{All change order of Plans dated 2/29/80 were prepared by Hwy-DB}

{3}-Denotes changes to C.O. ADD 232 - 2/29/80

C.O. ADD. 232

STATE OF HAWAII
DEPARTMENT OF TRANSPORTATION
HIGHWAYS DIVISION
H-1 VIADUCT (E.B. & W.B.), RAMP A, RAMP F & RAMP G
LONGITUDINAL SECTION
SH. 2 OF 2
KEEHI INTERCHANGE
F.A.I. PROJ. NO. I-HI-1 (131):17
SCALE: AS SHOWN DATE: AUG. 31, '77
SHEET NO. S-5 OF 5-94 SHEETS

GENERAL PLAN

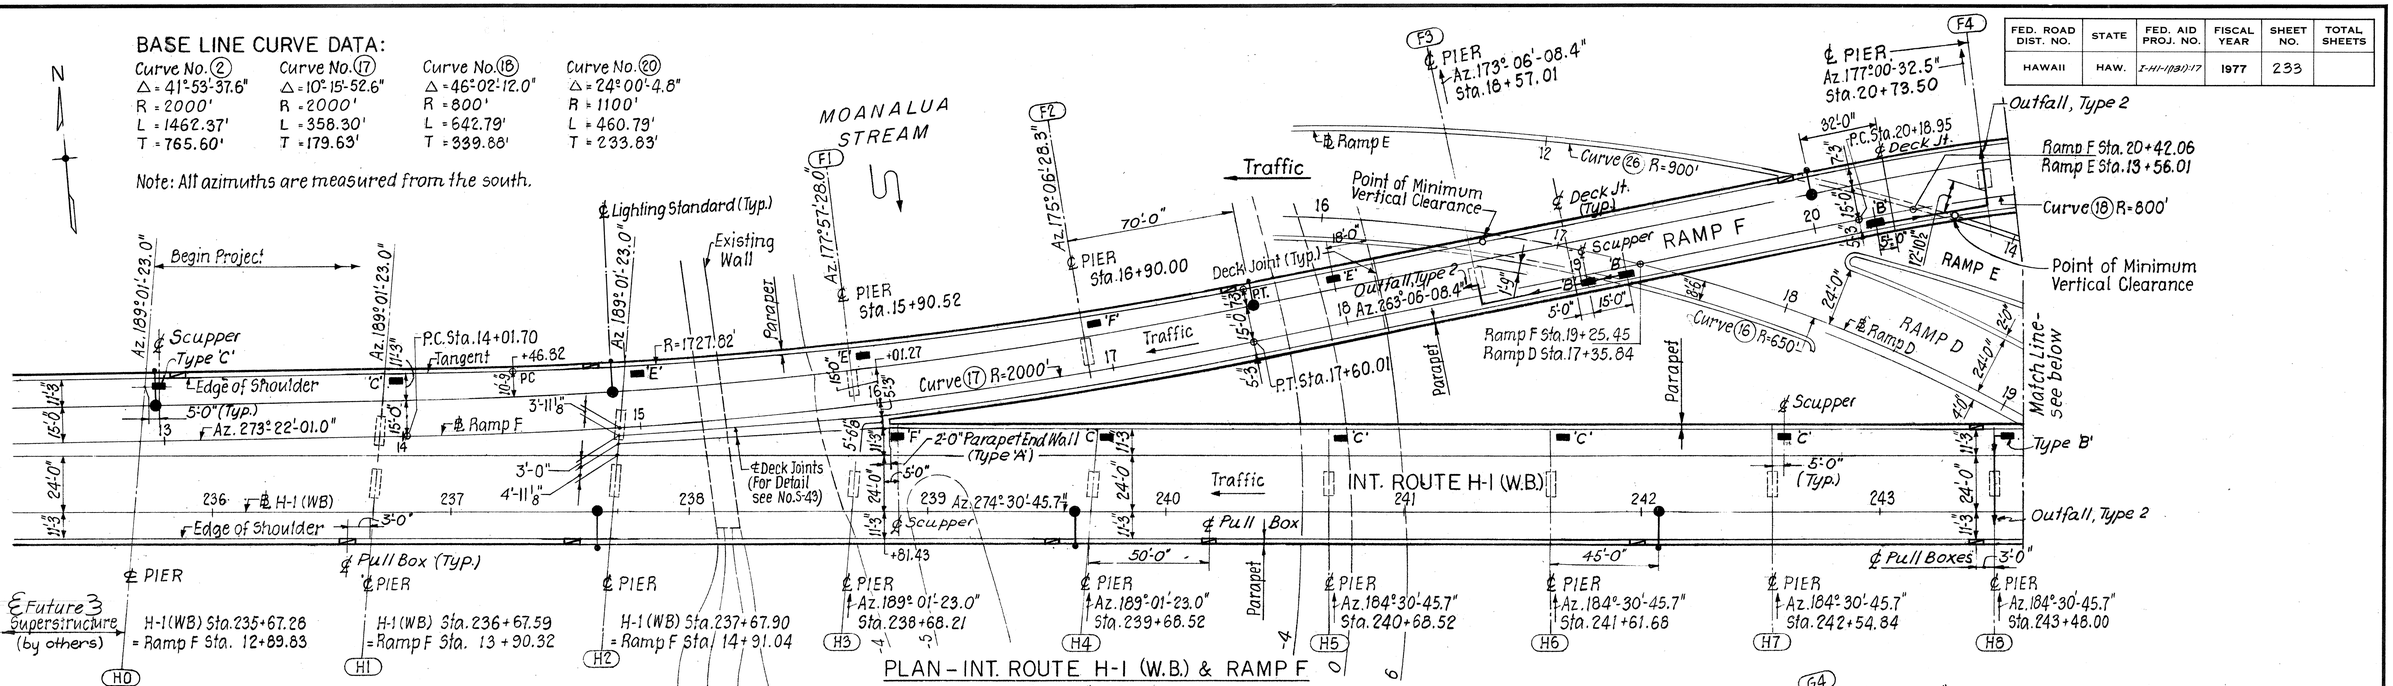
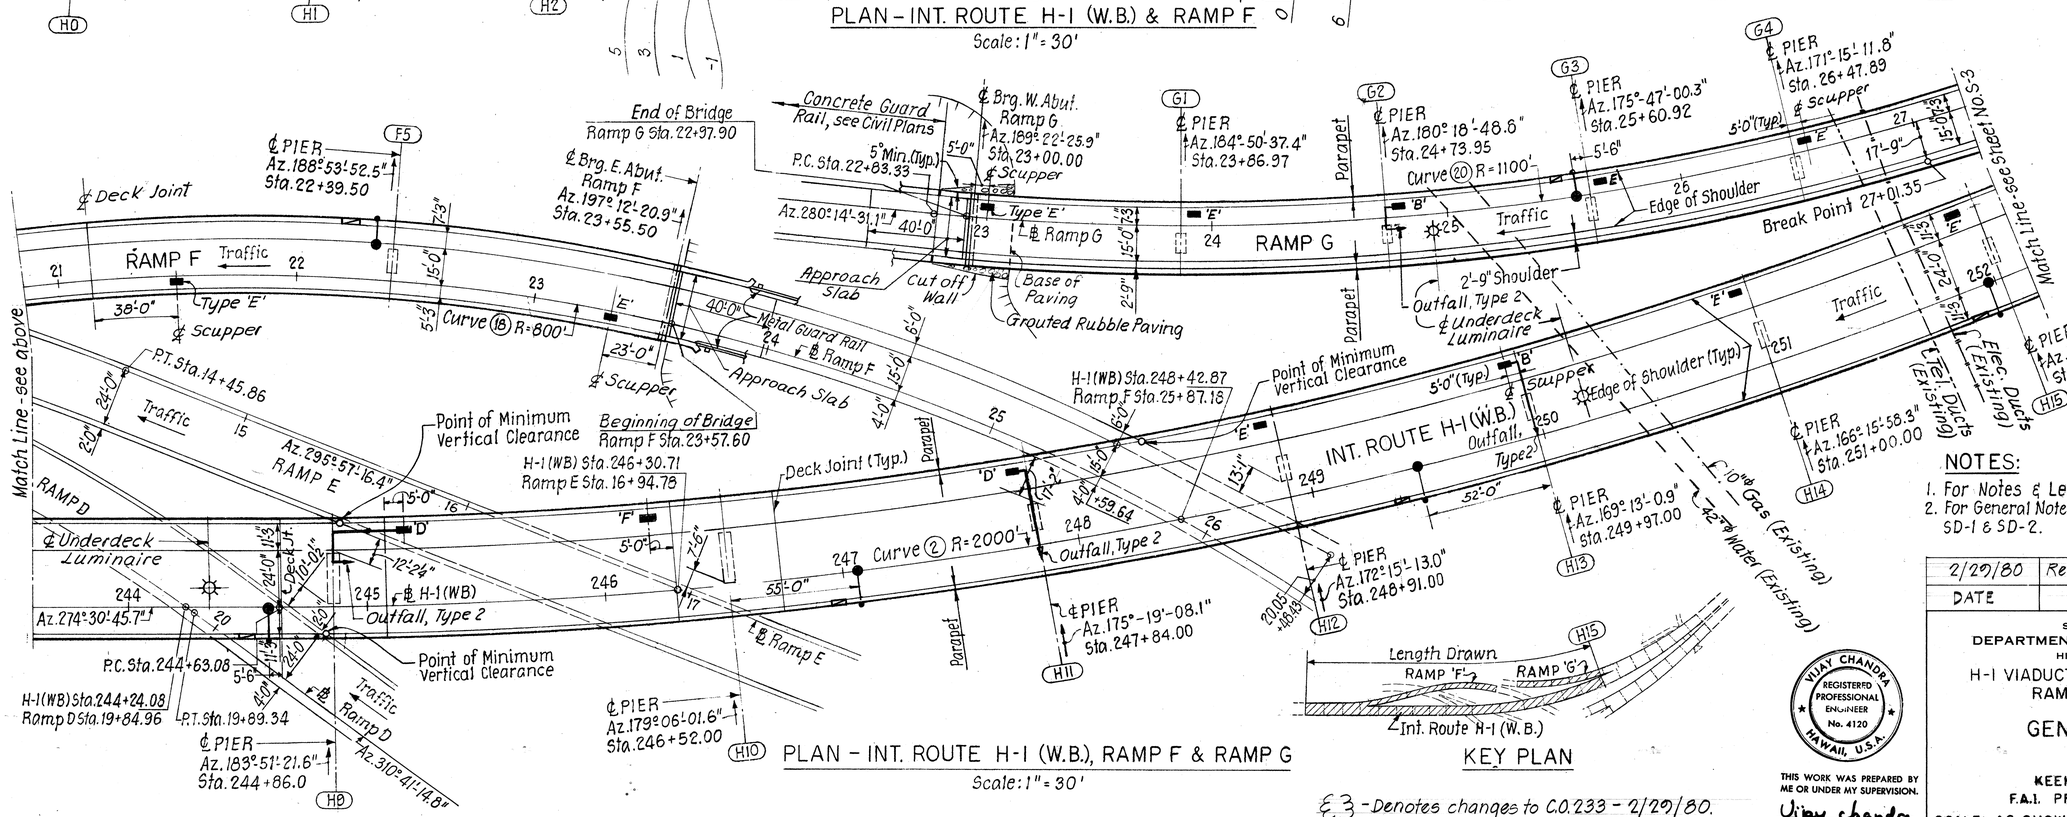
DATE	REVISIONS
2/29/80	Revised note at Pier (H0).

LONGITUDINAL SECTION – INT. ROUTE H-1 (W.B.) (Taken at Baseline)

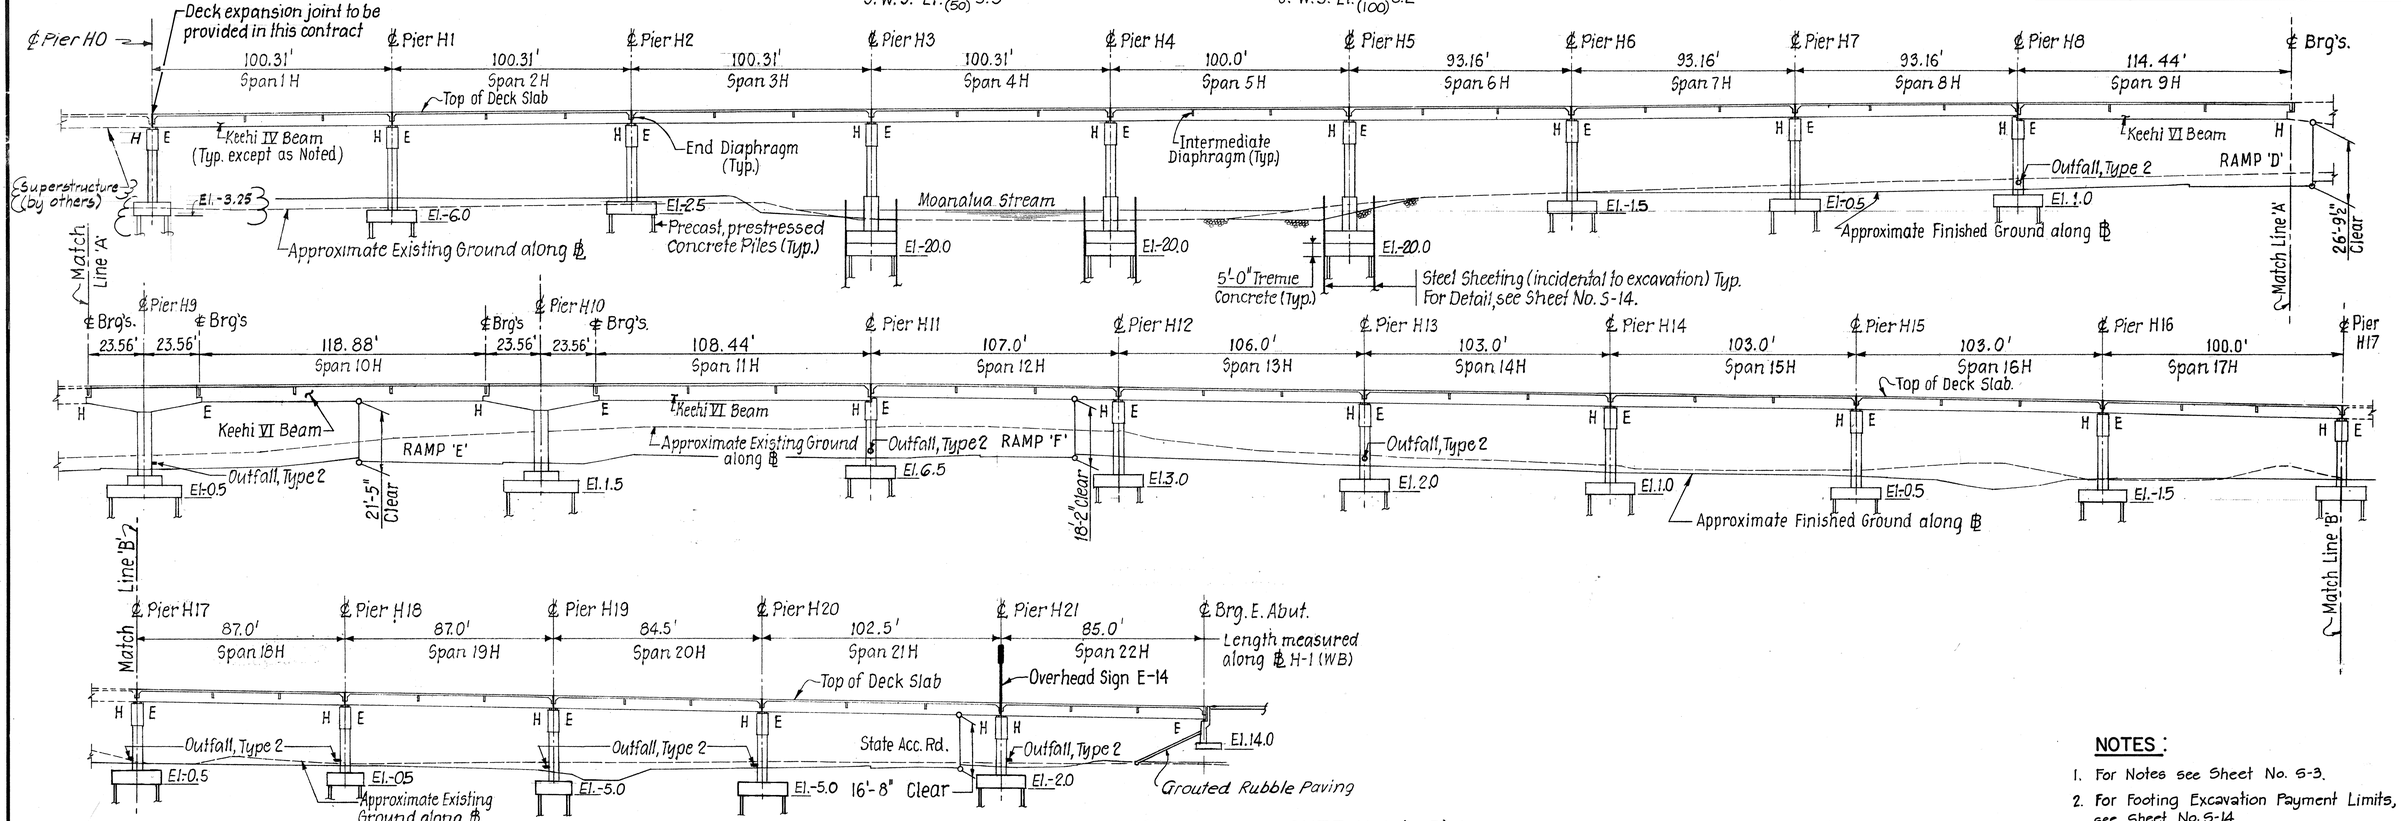
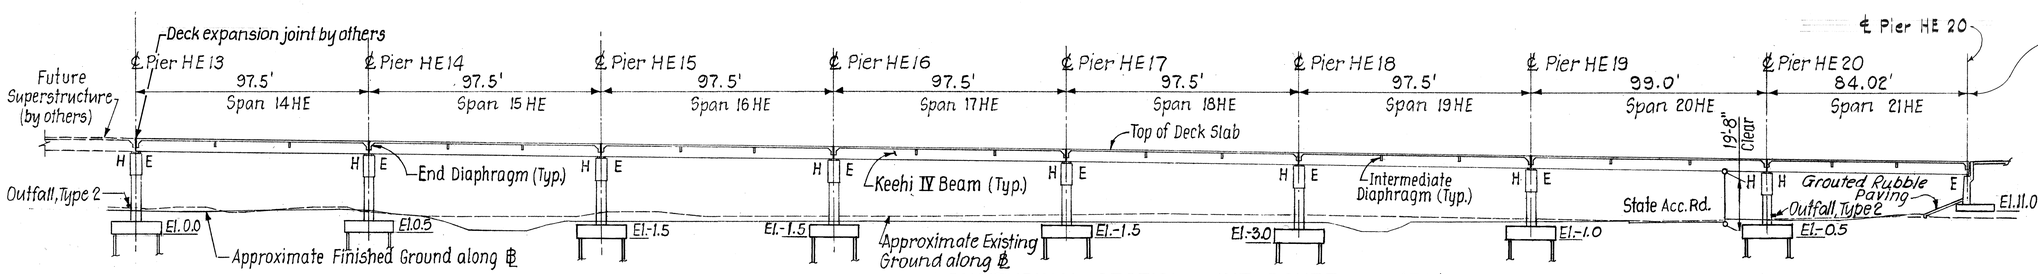
DATE	REVISIONS
2/29/80	Revised Pier and notes at Pier H0
12-18-78	Revised Mean Sea Level Elevation on Moanalua Stream Notes. Revised minimum vertical clearance on span between piers H20 and H21
7-21-78	Revised Footing Elevations

LONGITUDINAL SECTION – RAMP F (Taken at Baseline)
Scale: 1" = 30'

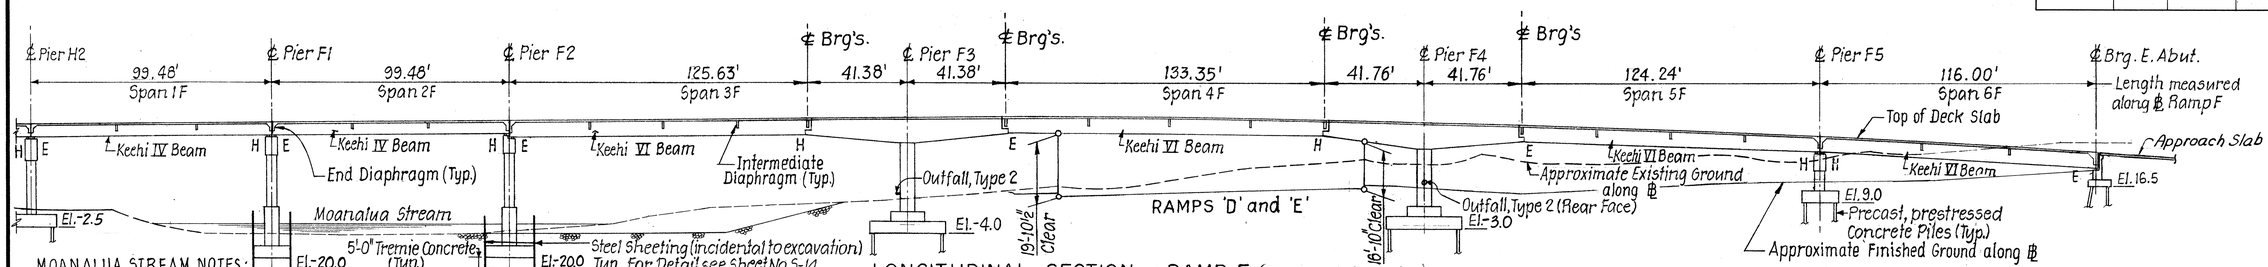
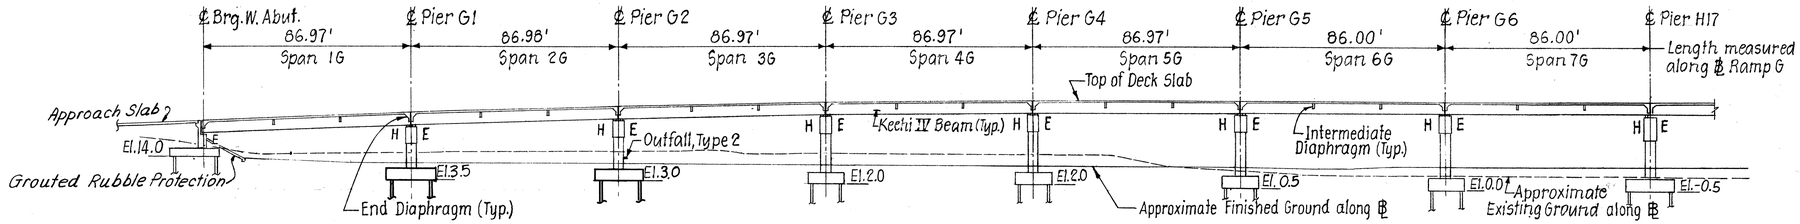
DATE	REVISIONS
7/21/78	Revised footing elevations.

FOOTING LOCATION PLAN
SHEET 3 OF 3

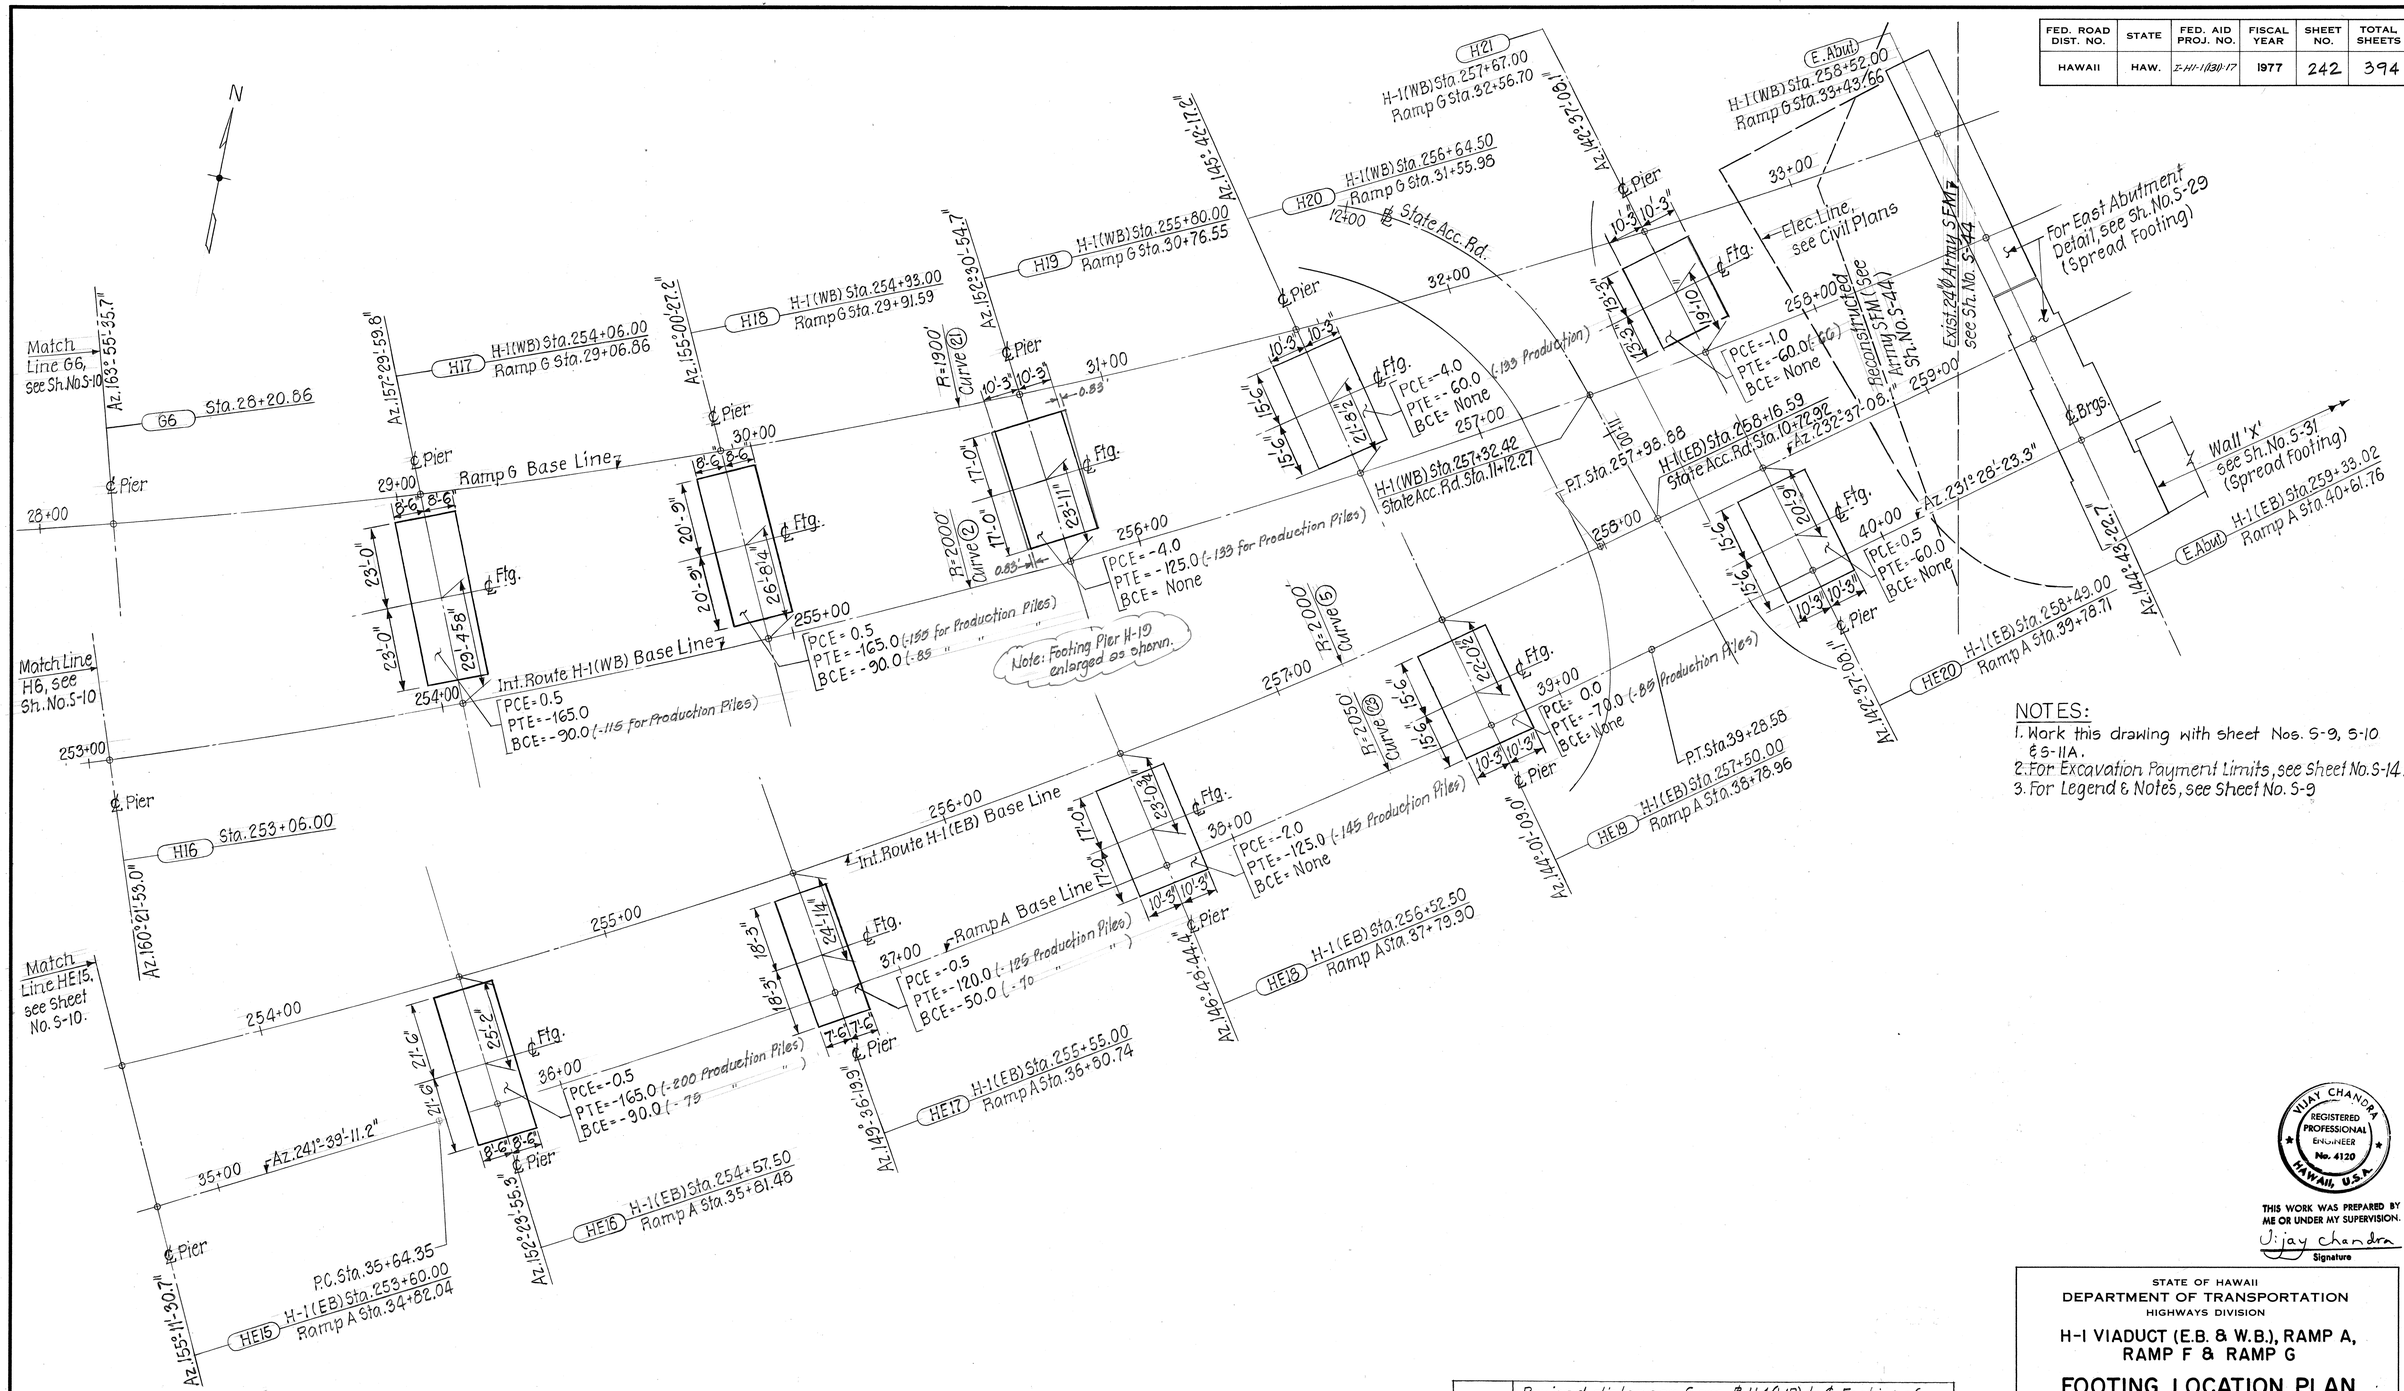
DATE	REVISIONS
12-18-78	Revised distances from ℄ H-1(WB) to ℄ Footing of Piers H 20 & H 21. Revised Footing size of Pier H 21.
7/21/78	Revised footing sizes, pile elevations and Note 1. Deleted Footing Types and Table. See Sheet No. C.O. 242 S-1 for footing types

~~PIER~~ H0 PILE CUT-OFF ELEVATIONS

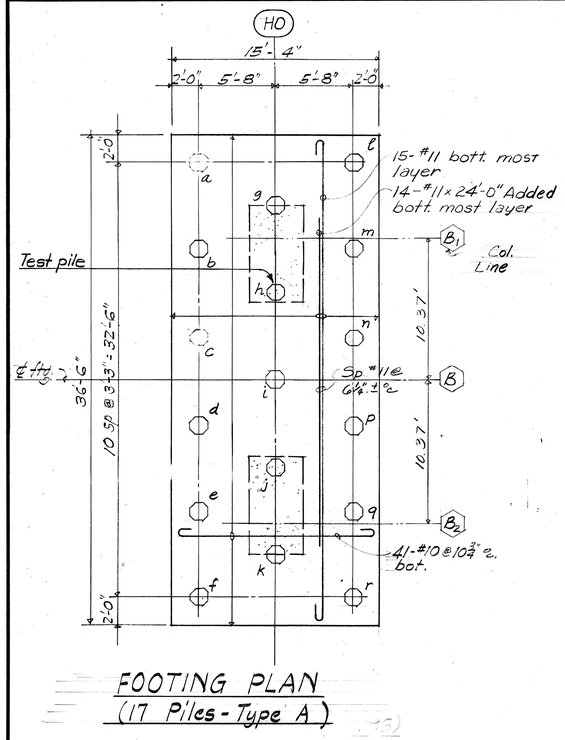
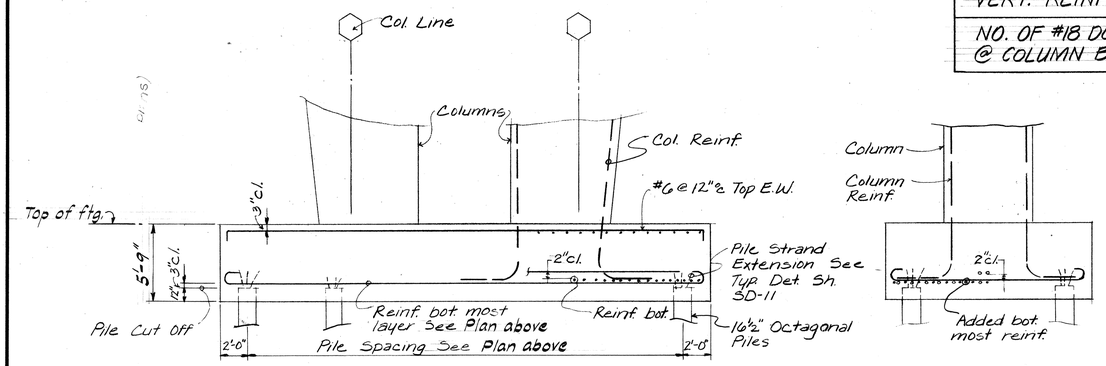
DATE	REVISIONS
2/29/80	Sheet added to contract plan set for Pier H0 only.
